May 14, 1980

ERRATA

Please make the following corrections to your copy of the  
Proposed Rulemaking Statement of Position,  
DOE/NE-0007

Figure III-3. Summary Logic Network Activities Leading to Geologic Repository Operation (Extended duration for characterization, licensing, and construction)

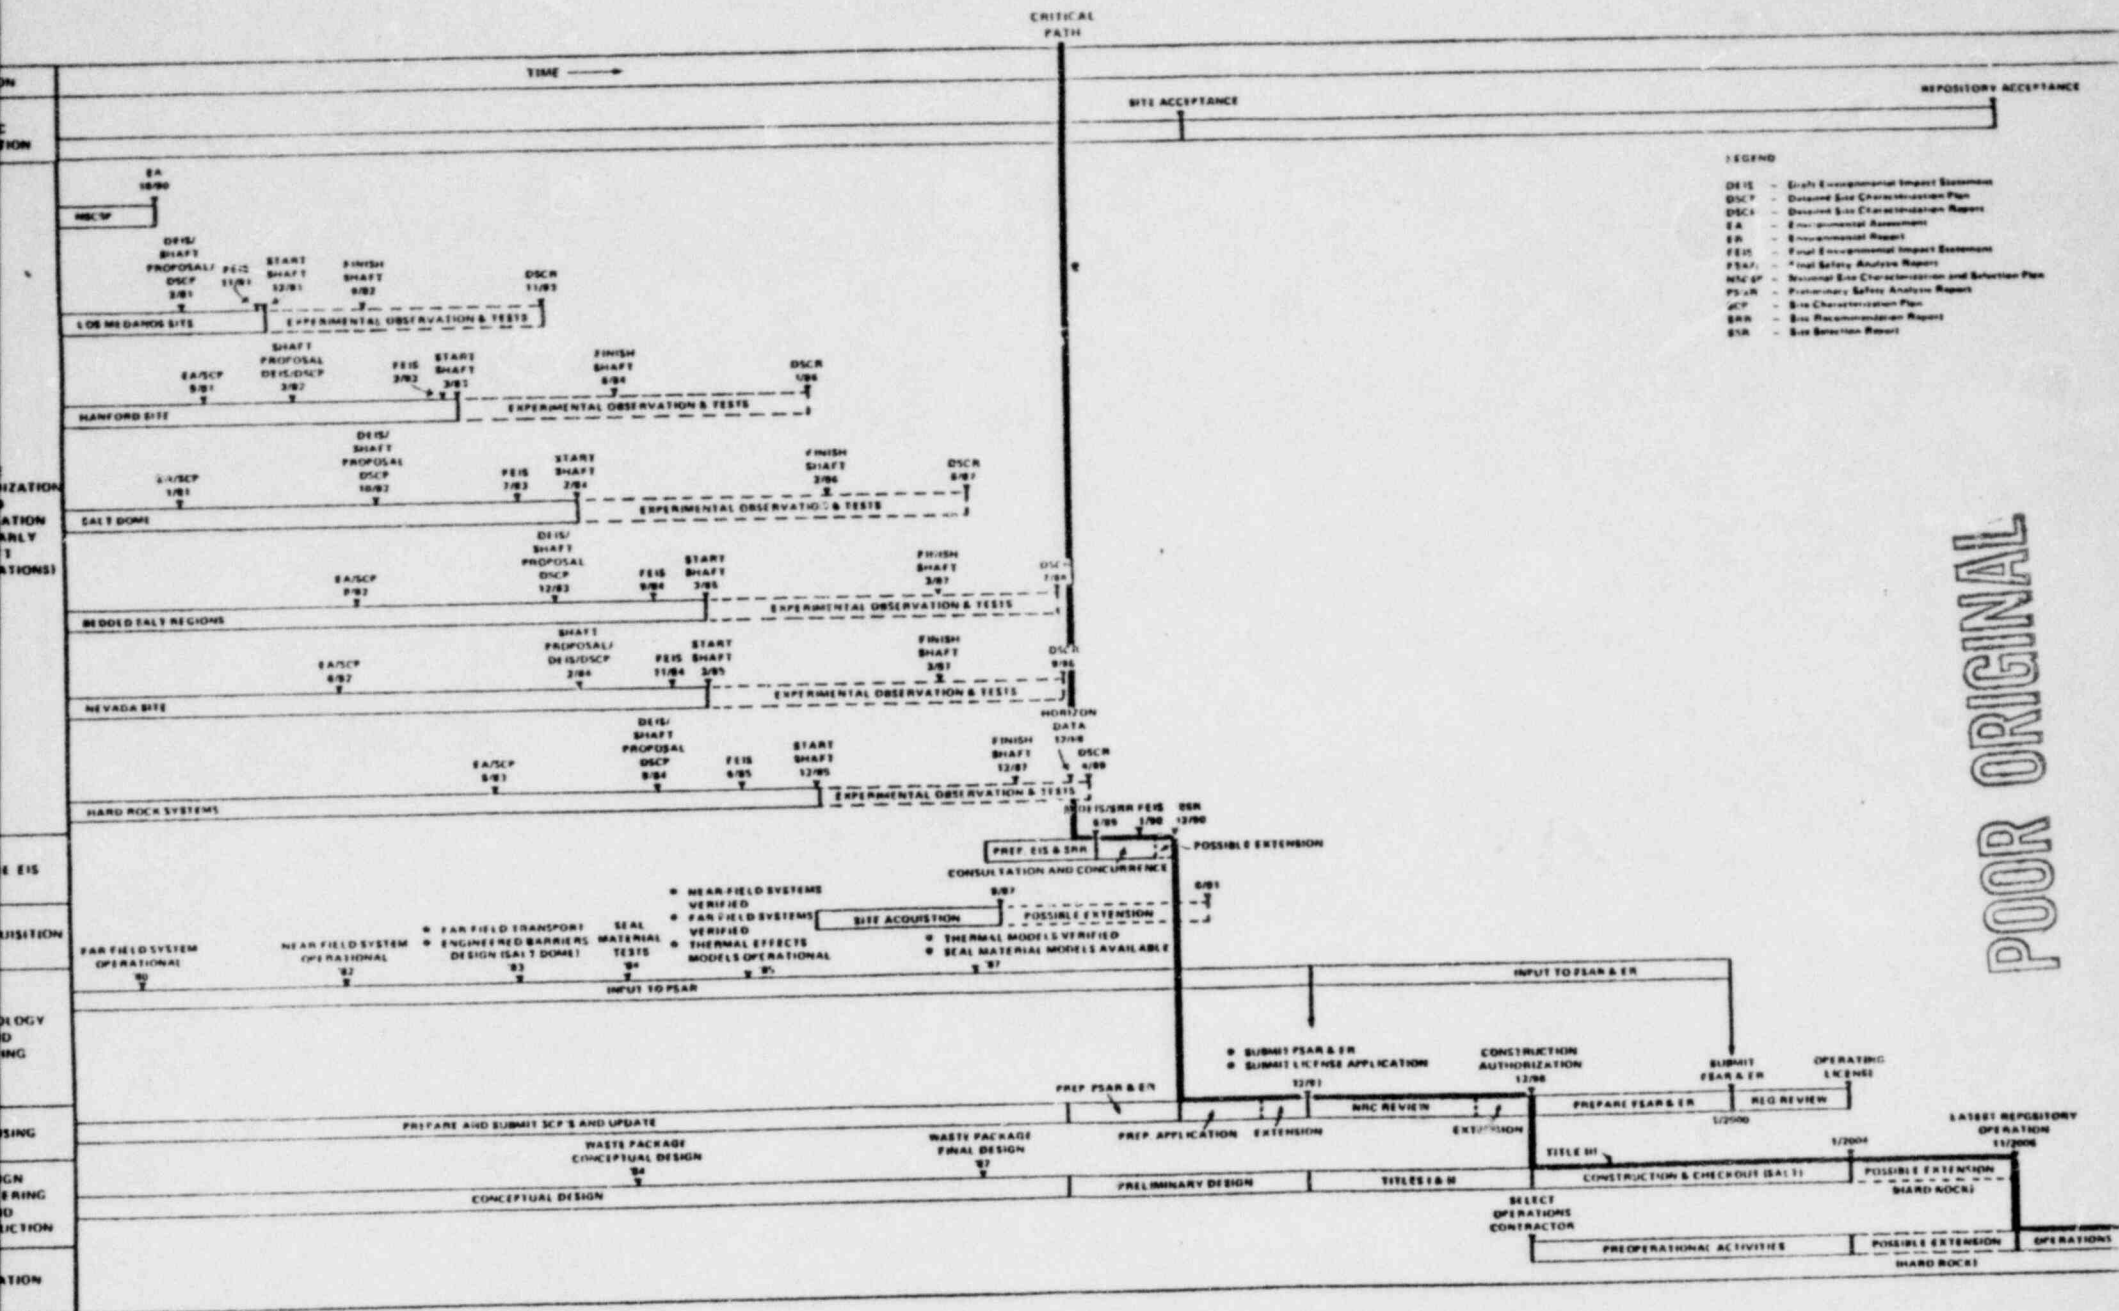
<u>Page No.</u>	<u>Correction</u>
III-11 & III-83	Substitute corrected Figure III-3, attached.
III-45, III.D.2.1.1.2	In First paragraph, 12th Line add "provinces within" before "the United States".  In first paragraph, 13th line delete the sentence starting with "The USGS-designated provinces..." and substitute "the provinces are shown in Figure III-5".
III-46	Replace Figure III-5 with corrected Figure III-5, attached.
